Enclosure (1) is the Final Parcel E Nonstandard Data Gaps Investigation Landfill Liquefaction Potential, Hunters Point Shipyard.

Enclosure (1) Final Parcel E Nonstandard Data Gaps Investigation Landfill Liquefaction Potential, Hunters Point Shipyard, August 13, 2004

**FIGURE 1
 FACILITY LOCATION MAP**

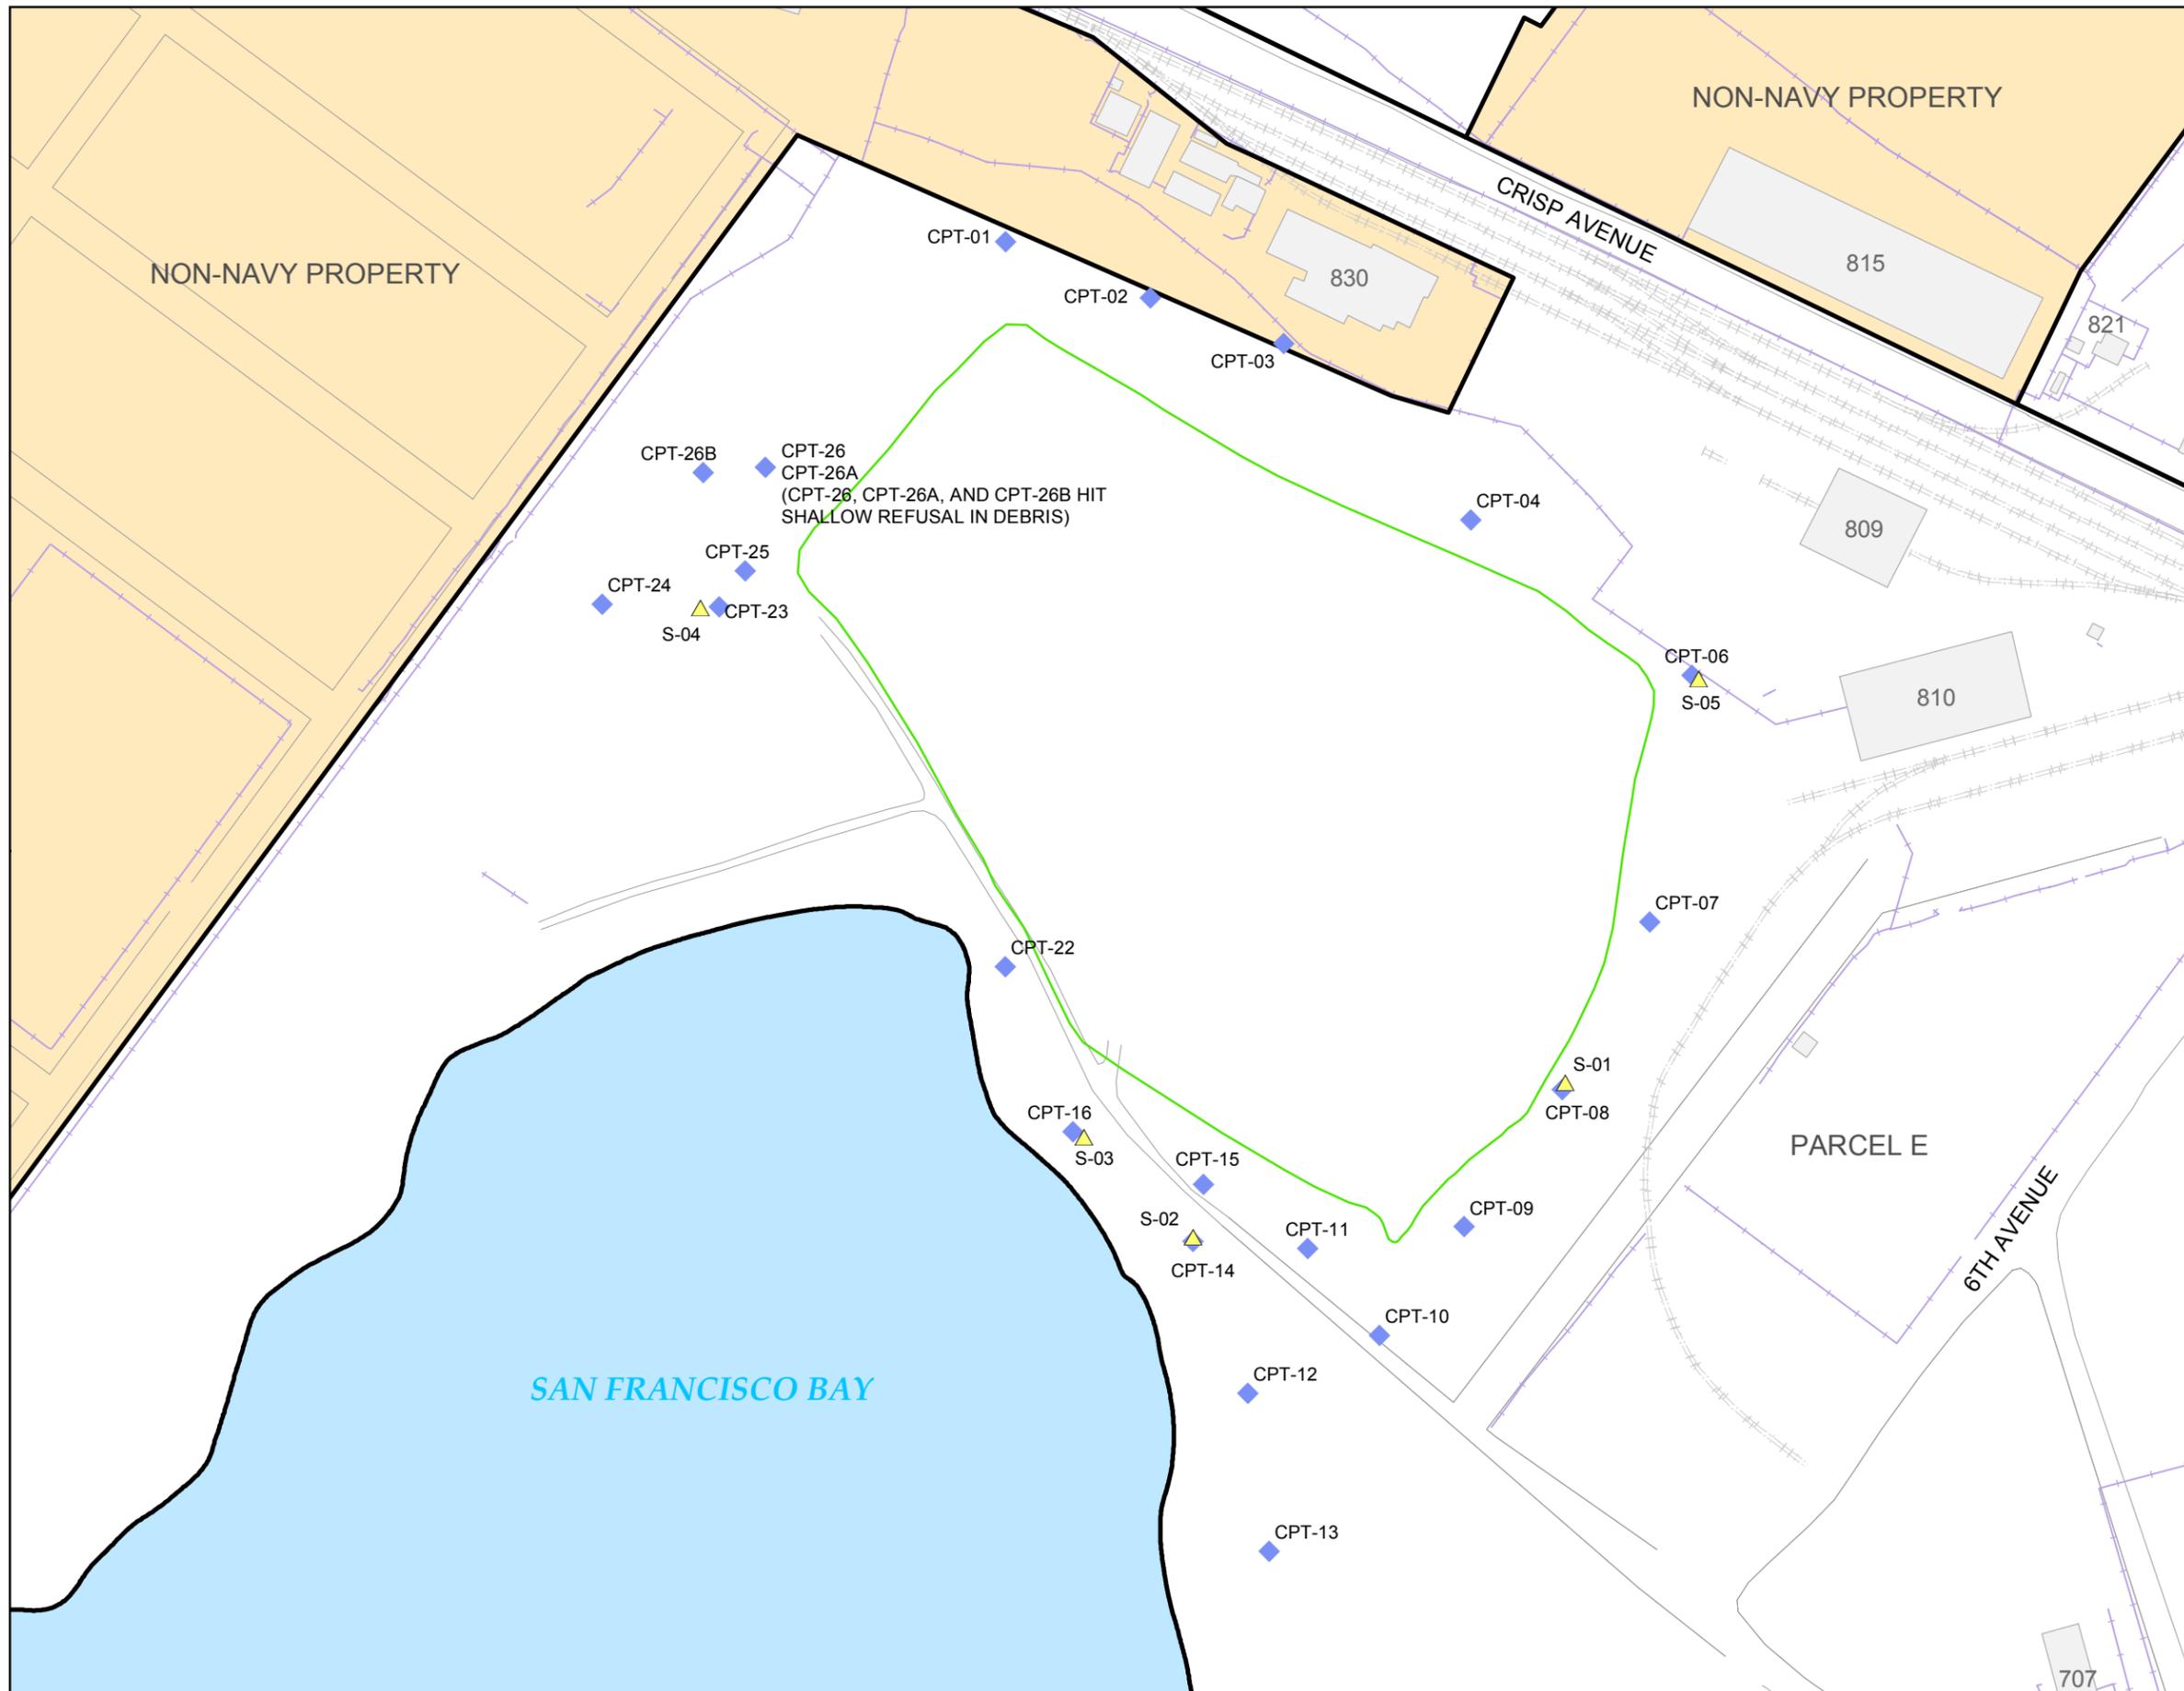
9. **Comment:** **Figure 1: Facility Location Map:** Similar coloration of parcel boundary and roads makes it difficult to easily identify parcel boundaries. Please consider revising to make it easier to read.

Response: [Figure 1](#) has been revised to differentiate the parcel boundaries and the roads.

FIGURE 2
SPT AND CPT LOCATION MAP
 Parcel E Nonstandard Data Gaps Investigation
 Landfill Liquefaction Potential

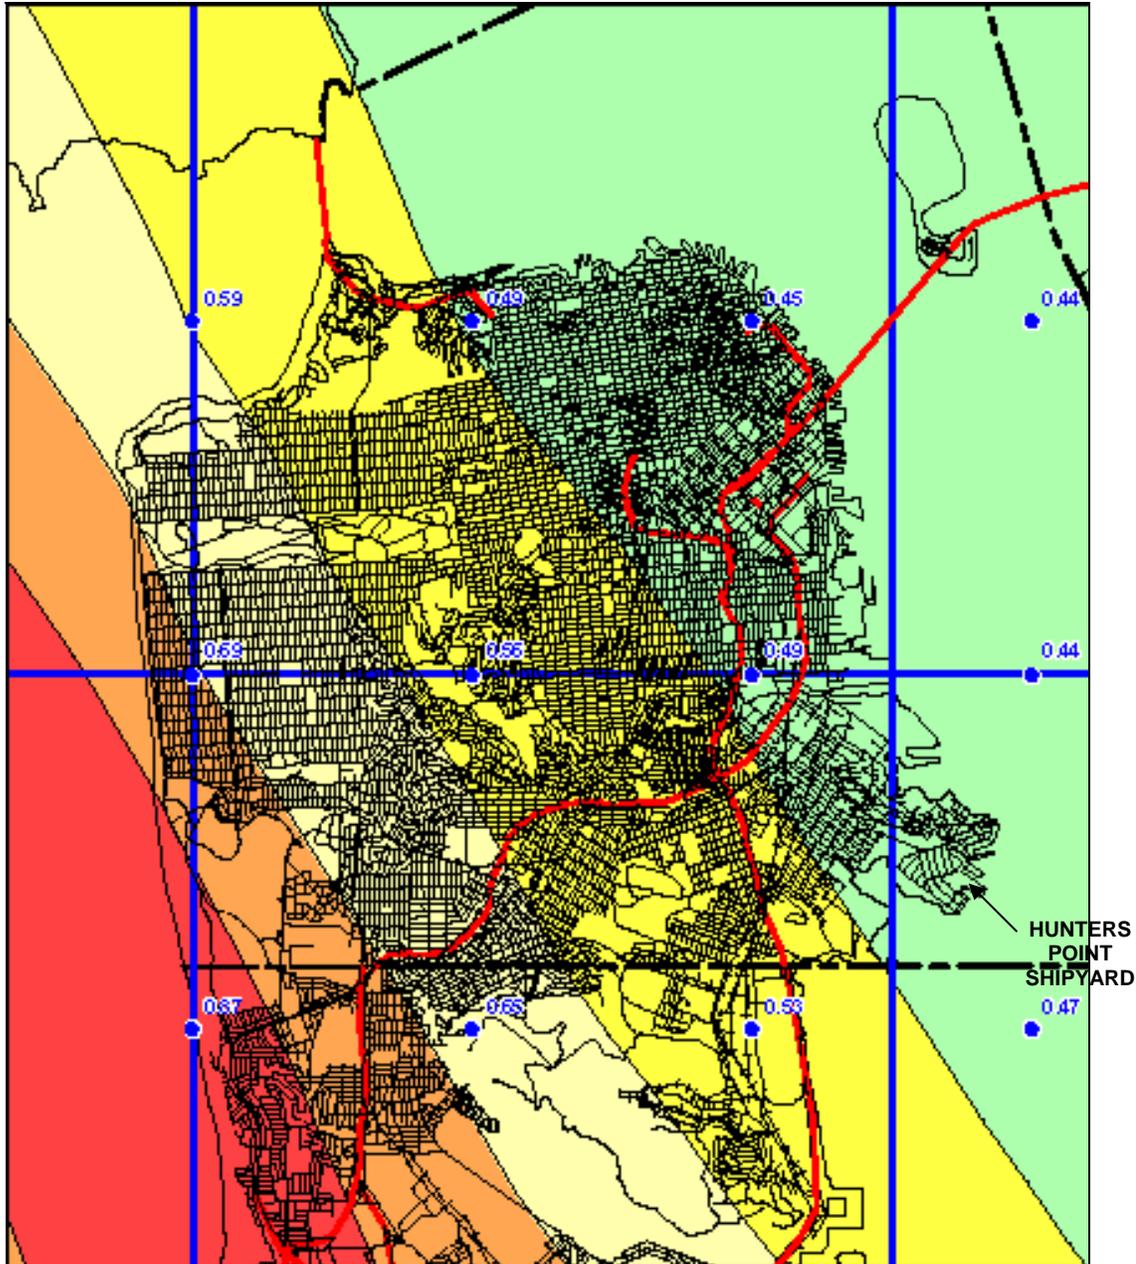
10. Comment: **Figure 2: SPT and CPT Location Map: Notation in legend for SPT differs from notation on actual figure (legend references “SPT” but map uses “S”). Please consider revising the figure so that legend and actual notation correspond.**

FIGURE 7
MAJOR FAULTS OF THE SAN ANDREAS
FAULT SYSTEM WITHIN 50 KILOMETERS OF
HUNTERS POINT SHIPYARD
 Parcel E Nonstandard Data Gaps Investigation
 Final Landfill Liquefaction Potential

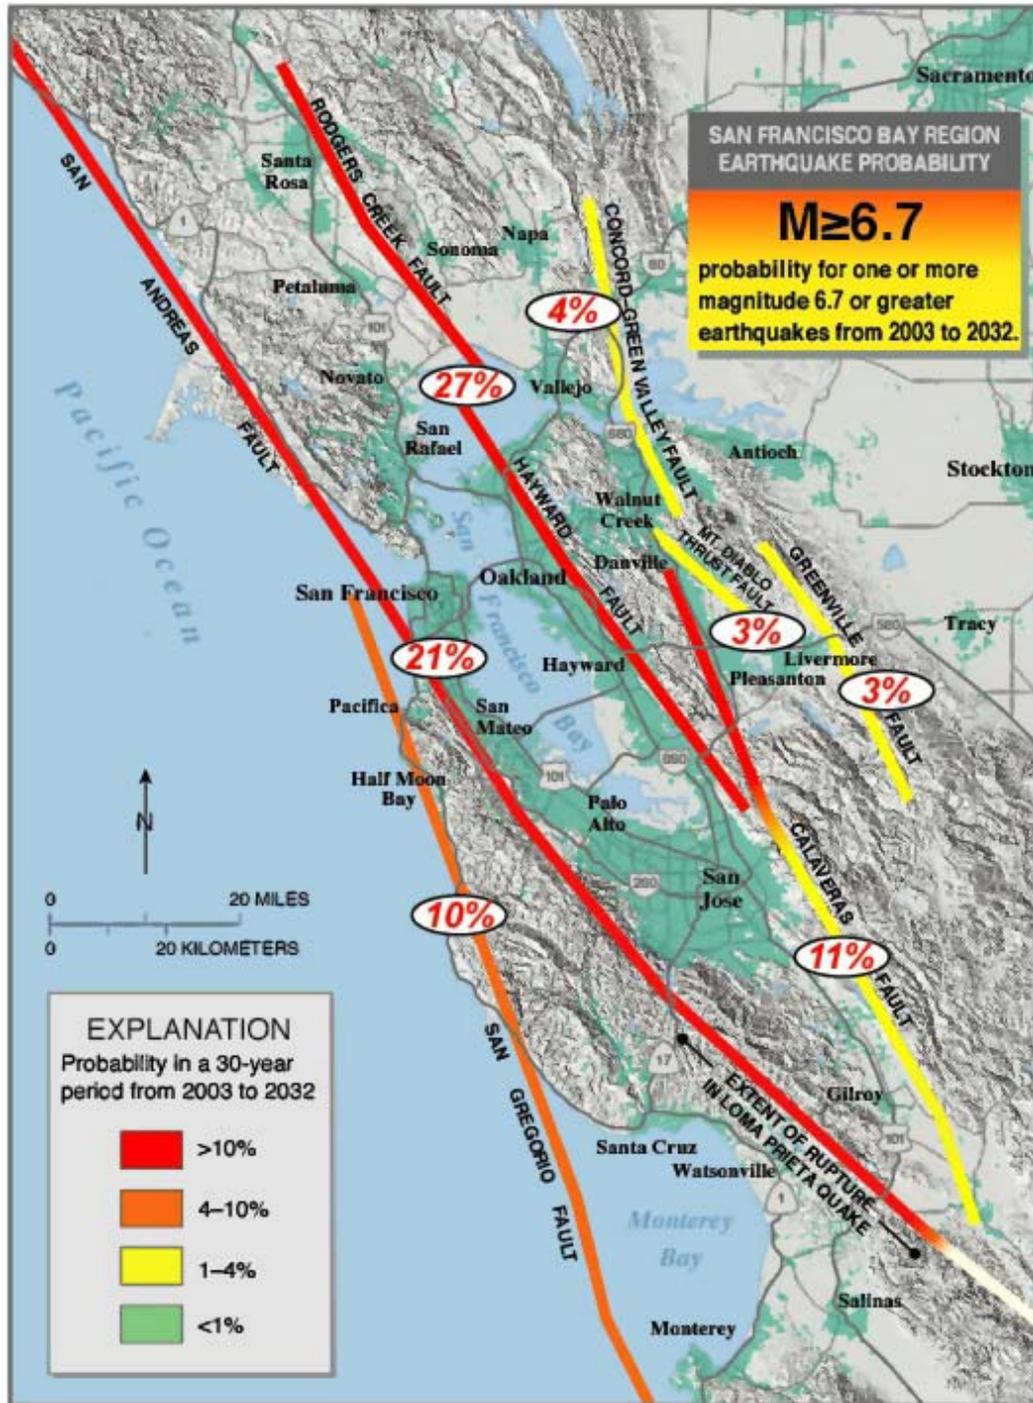
30. Comment: Figure 7 - The design earthquake used in the liquefaction potential evaluation is a Mag. 7.9 with an epicentral distance of 12km whereas Figure 7 from the DMG study in the Hunters Point area indicates a source event of Mag 7.3.

11. Comment: **Figure 4: Major Faults of the San Andreas Fault System Within 50 km of Hunters Point Shipyard: Figure referenced appears to be from <http://quake.wr.usgs.gov/research/seismology/wg02/summary/> not from <http://quake.wr.usgs.gov/research/seismology/wg02/>. Please verify the source and correct the reference, as needed.**

Response: A. PGAs for the evaluation of liquefaction were estimated using the MPE and results of the seismic hazard evaluation by [DMG \(2000\)](#). A PGA of 0.5 g was indicated using an M7.9 earthquake on the Peninsular segment of the San Andreas Fault by applying the attenuation relationship in [Boore and others \(1997\)](#).

Response: The referenced website on [Figure 4](#) has been corrected.
